CERTIFICATE OF APPROPRIATENESS

Applicant: Gail Schorre, Morningside Architects LLP for Mark and Linda Margavio, owner

Property: 1832 Columbia Street, lot 20, block 108, Houston Heights Subdivision. The property includes a historic 1,036 square foot historic residence situated on a 6,600 square foot (50' x 132') interior lot.

Proposal: Alteration – *Revision*: Construct a two story 1,584 square foot addition and attached two story rear garage with 400 square feet of living space to the rear of a one story contributing residence. The applicant initially submitted a COA application last month that staff found to not meet criteria 1, 4, 8, and 9 for alterations to Contributing structures. The application was deferred at the December 17, 2014 HAHC meeting in order to allow staff time to review revisions discussed at the meeting by the applicant. The applicant and owner have since met with staff and agreed to revise their previous design.

WEST ELEVATION – FRONT FACING COLUMBIA STREET

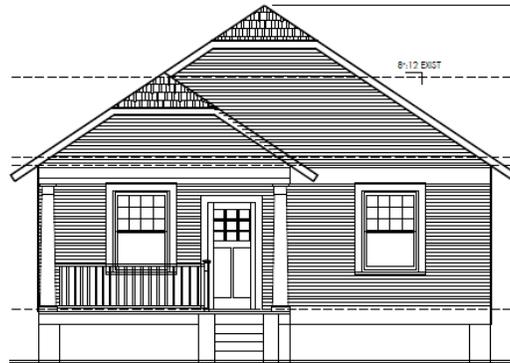
Front Elevation: The front elevation of the existing house will not be changed. The addition will measure approximately 7' taller than the existing structure measuring from the existing ridge to the ridge of the addition. The attached garage will be located at the rear of the property and will feature a front facing garage door.

NORTH SIDE ELEVATION

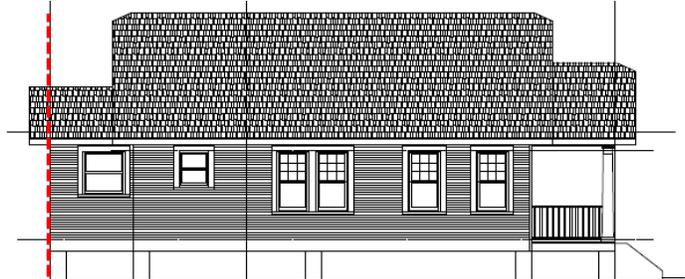
Side Elevation: The addition will begin at the rear of the existing structure. The main portion of the addition will feature a band of 3 windows on the first floor and three windows on the second.

SOUTH SIDE ELEVATION

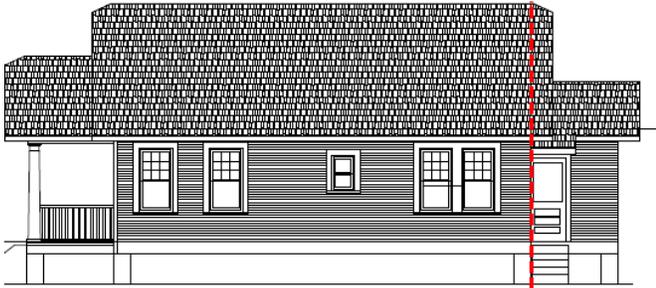
Side Elevation: The addition will begin at the rear wall of the existing structure. The main portion of the addition
(South) will feature two windows on the first floor and four on the second. The garage will be attached to the addition by a front facing carport.

PROPOSED SITE PLAN

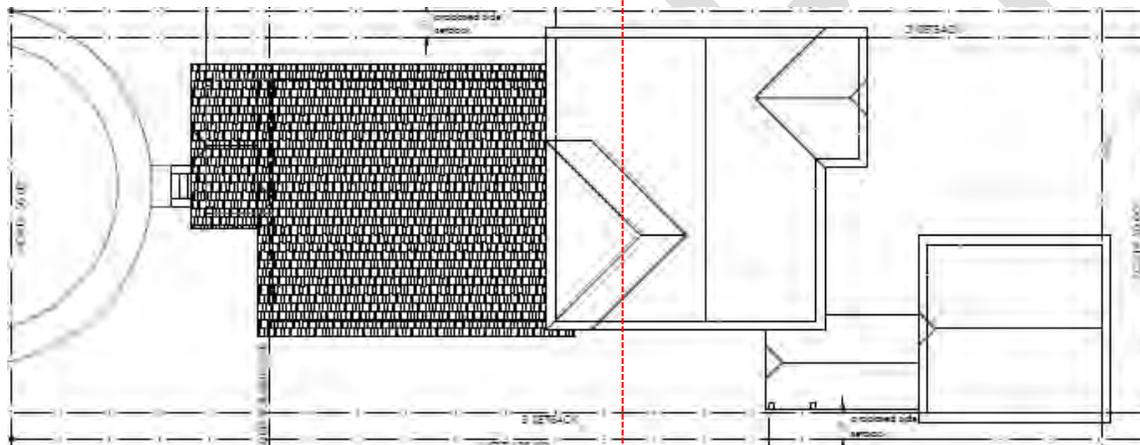
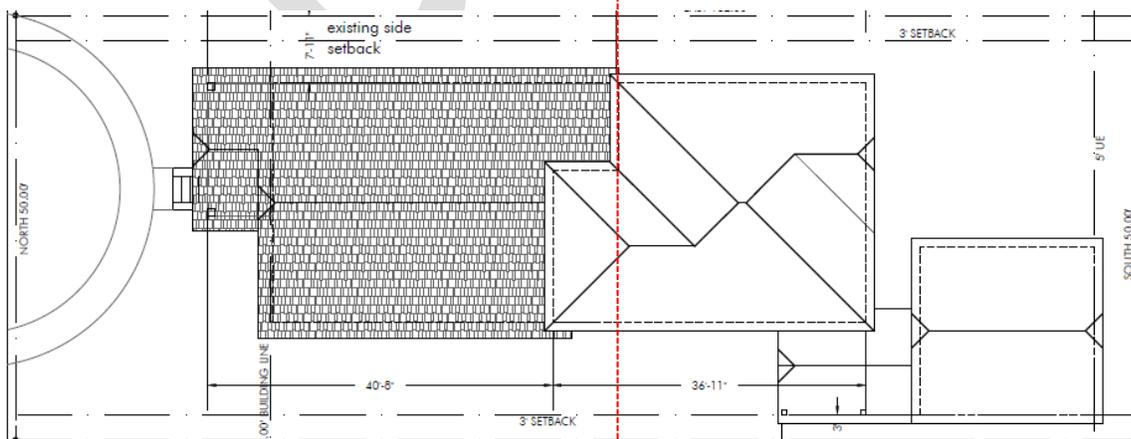
Setbacks: **Deferred 12/17/14:** *The existing residence is set back 23' 3" from the west (front) property line, 13' 9" from the south, and 7' 11" from the north. The main portion of the proposed addition will be built to within 3' of the north side setbacks but will not change the existing south setback. The proposed attached garage-carport portion will be set back 88' 3" from the front property line and will be built to within 3' of the southern property line but will not impact the north setback. When combined, the addition in its totality will extend to 3' of each side setback.*

Proposed Revision: The main portion of the proposed addition will not extend beyond the setbacks of the existing residence.
